SDNP Landscape and Visual Impact Appraisal and assessment of effects on access to the SDNP

A27 Arundel: Route option 3

April 2017

drawing title: Physical effects (Arundel section: Option 3)

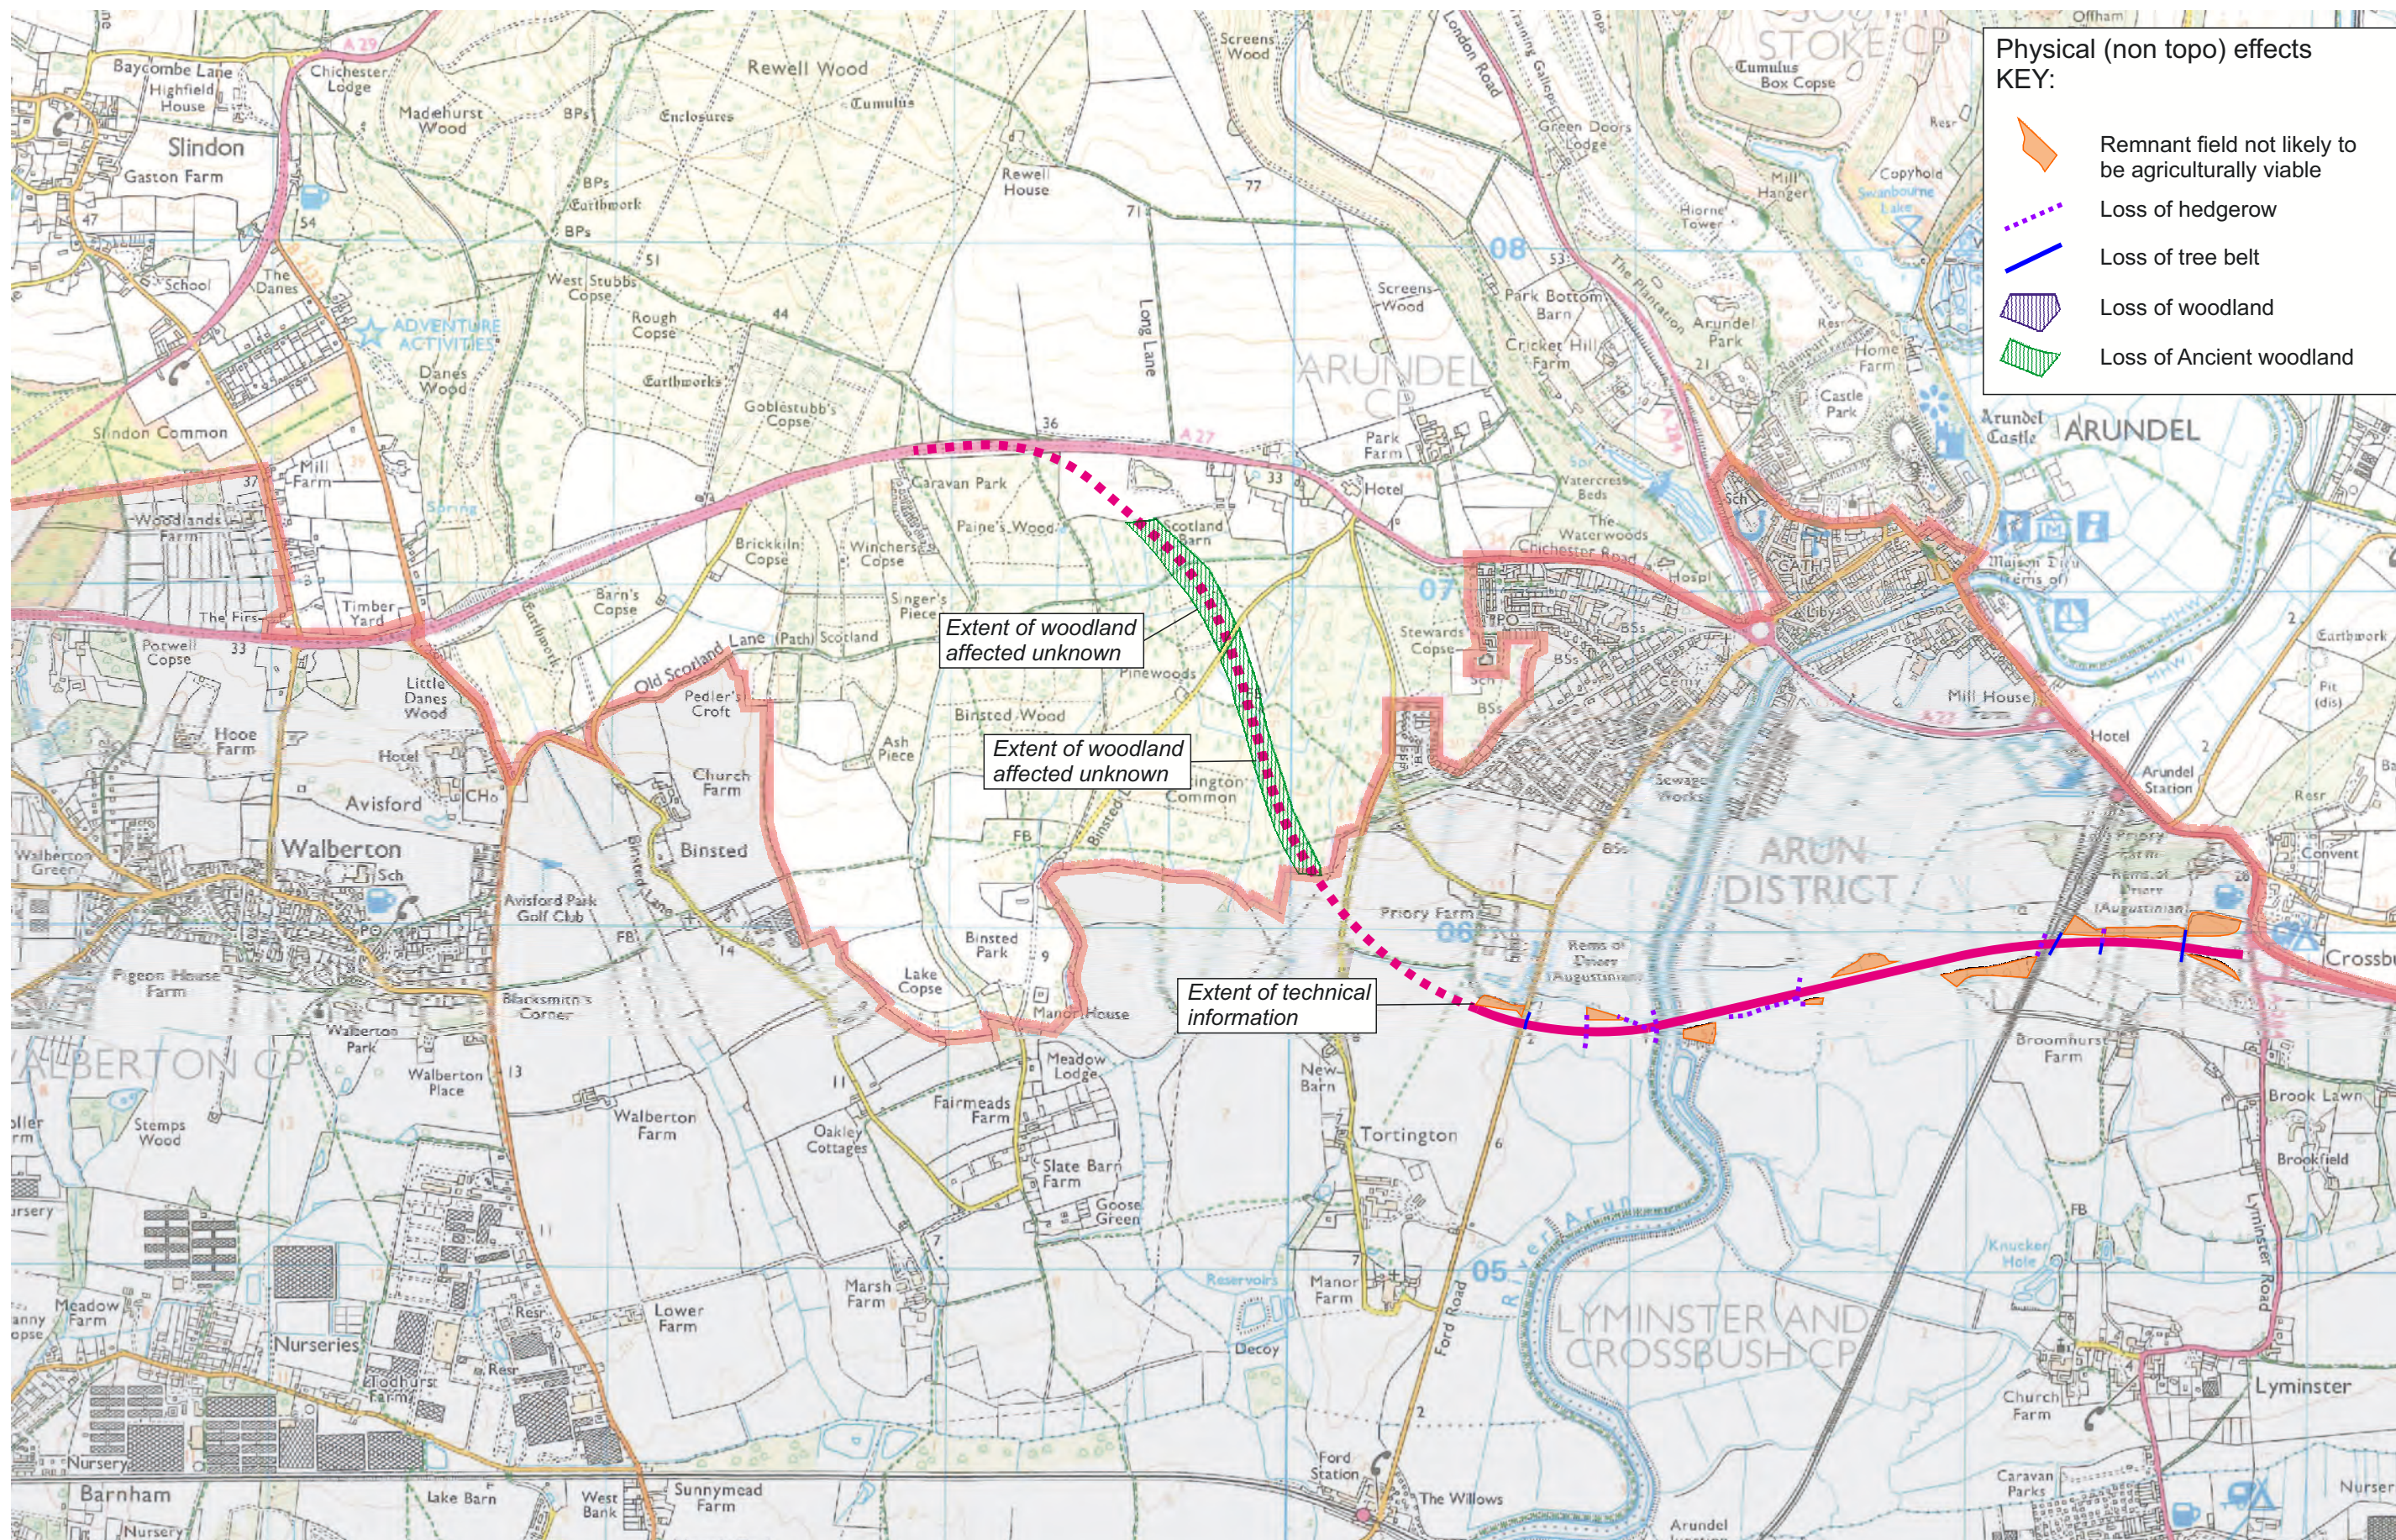
southern edge of the woods at Tortington Common. This vegetation clearance would not be a physical change within the SDNP. At the point where the option 3 road improvement alignment would enter into those woods (and also enters the SDNP), extremely adverse physical interventions in the landscape would clearly be caused by clearing vegetation along a 1.9km course through Tortington Common / Binsted Wood (which is recorded in Natural England's inventory of ancient woodland). The width of the proposed road improvement has not been indicated in the design information provided by Highways England to-date. However, it has been estimated that the road improvement scheme would require clearance of approximately 24ha of woodland vegetation. This would consist not only of the coniferous plantation treecover, but perhaps more significantly would of course also erase the rich and varied woodland understorey flora and fauna.

drawing title: **Effects on the PRoW network / connectivity to the SDNP (Arundel section: Option 3)**

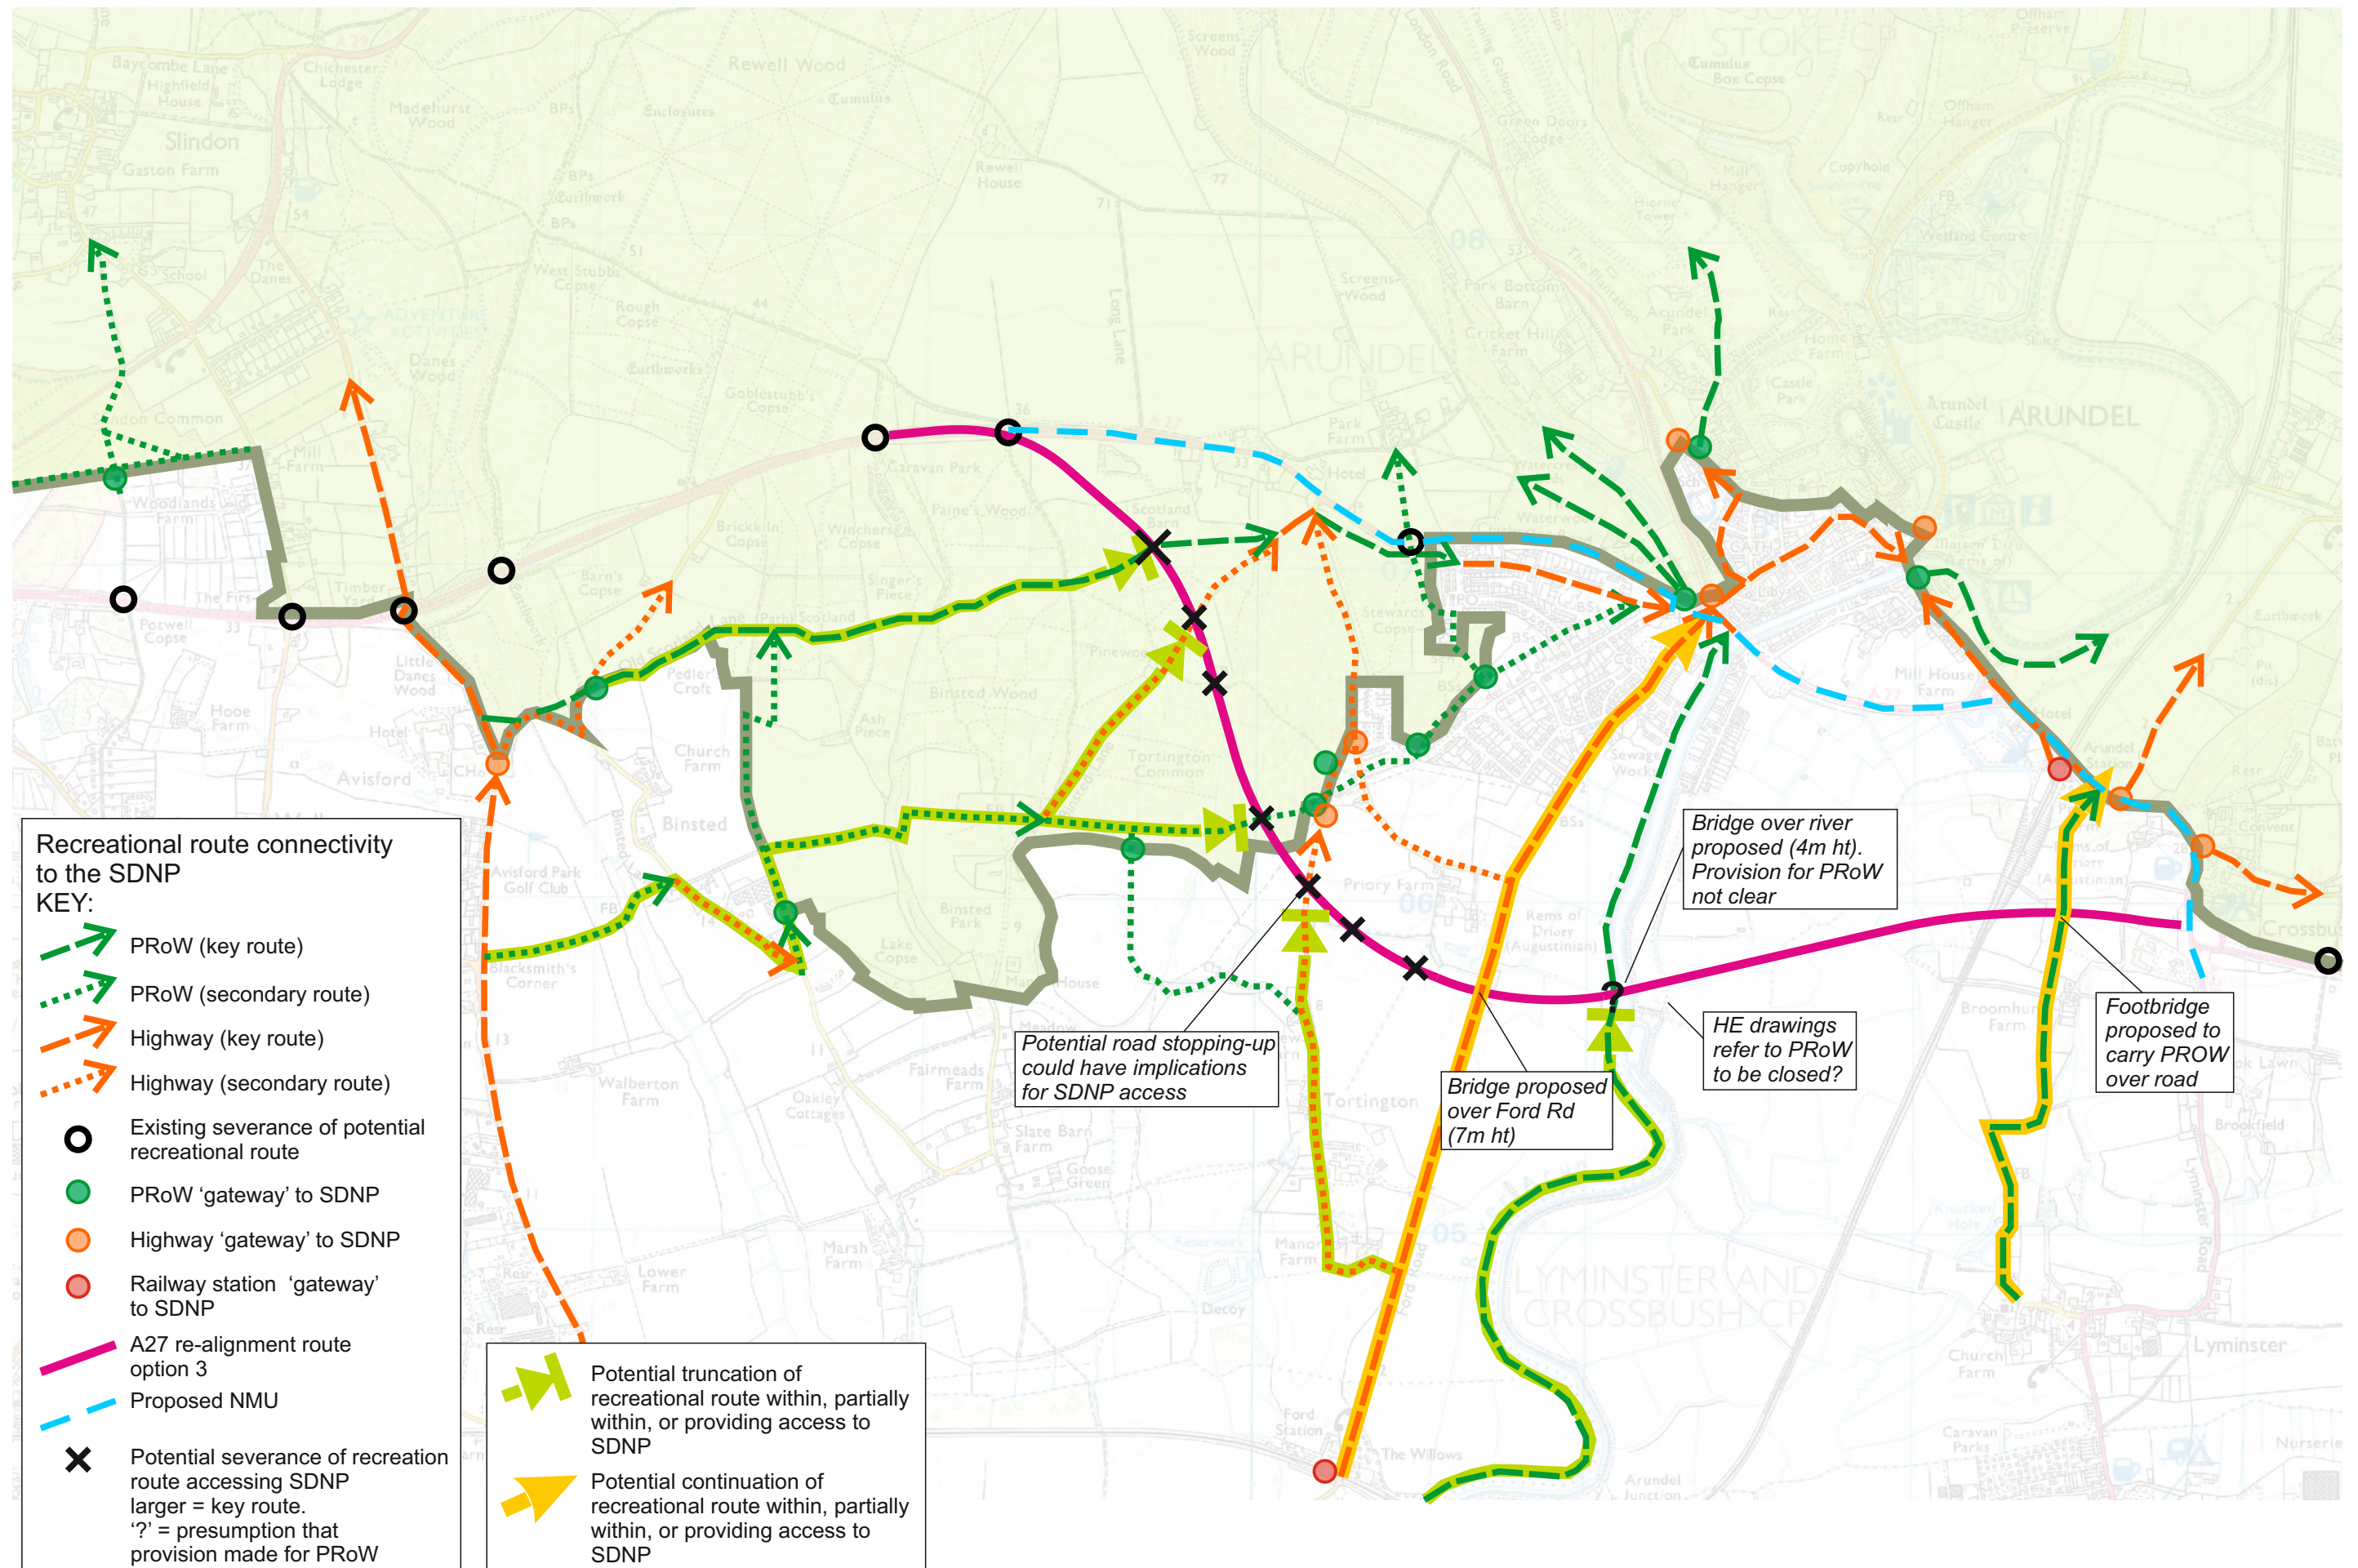
For the eastern part the Option 3 route, crossing the Arun valley floor / floodplain, the technical drawings show that public footpath 2207 would be carried over the proposed carriageway on a new footbridge. Similarly, the proposed road improvement would not cause any severance of Ford Road, which would be continue as at present, with the re-aligned A27 carriageway carried over it on a new bridge. However, the technical drawings do not make clear what the design intent is in regard to public footpath 206. It should be noted that this public footpath is positioned at the top of the flood bank. The technical drawings indicate that the level difference between the top of this flood defence bank, and the centre of the proposed carriageway at the same position would be just over 2m. Allowing for the road / bridge construction, it is thought to be very unlikely that sufficient head clearance would be available for pedestrians to pass under the proposed bridge, on top of the flood bank on the existing alignment of public footpath 206. A diversion of the footpath off the flood bank here (in order to increase the head clearance) would be problematic, as the adjacent land is floodplain, known to periodically flood (hence the position of the footpath on top of the flood bank, above the floodplain).

Given the deficiencies of the technical design consideration given to-date, we consider that the implementation of road improvement Option 3 would effectively hinder access to the SDNP, as public footpath 206 would be severed, or at least its viable use (on a modified alignment) would be restricted to times when the floodplain is not in flood, unless the design of the bridge crossing is revised to allow sufficient head clearance over the footpath.

Within the SDNP, the option 3 route would cross the existing public footpaths 342, 347 then cross Binsted Lane, then Bridleway 338 (known as Old Scotland Lane), then public footpaths 347 and then the road improvement scheme ties-in to the existing A27 alignment at the same location as public footpath 3400. Of particular note, Bridleway 338, Binsted Lane and footpath 342 provide logical east-west connections between Walberton (outside the SDNP) and Arundel with the SDNP just beyond. It is thought that these have the potential to be key routes for recreational users
